Thor Motor Coach Recall Repair Instructions

Recall #	19V-417 2019-266		
Description/Title:	BB35/BH35 Junction Box		
Affected Product Line(s):	Certain MY 2019/2020 Magnitude & Omni motorhomes		
Service Campaign # :	RC000169	Released Date:	07/01/2019
Repair Code:	Inspect: TMCRC80483Y Repair: TMCRC80483V	Document Date:	07/01/2019
Time Allowed:	Inspect: 0.1 Repair: 0.4	Document Revision:	Α

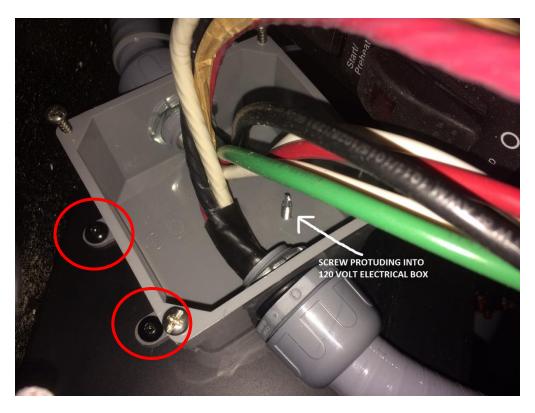
Inspect inside for extra screw through middle of box as show in picture below.
If there is no extra screw, you are done with recall.
If screw is present, please remove by accessing back of box via 1st compartment door.

- 4. Inspect wires to verify whether or not they have been compromised by the extra screw. Add electrical tape if needed.
- 5. Verify that box is secured to compartment wall by all 4 tabs (tabs circled below). If only secured by 2 tabs, remove box from wall, raise onto wall and secure by all 4 tabs with #8 self-tapping screws.

6. Caulk the hole in the junction box that was left from removing the screw to prevent any water intrusion.
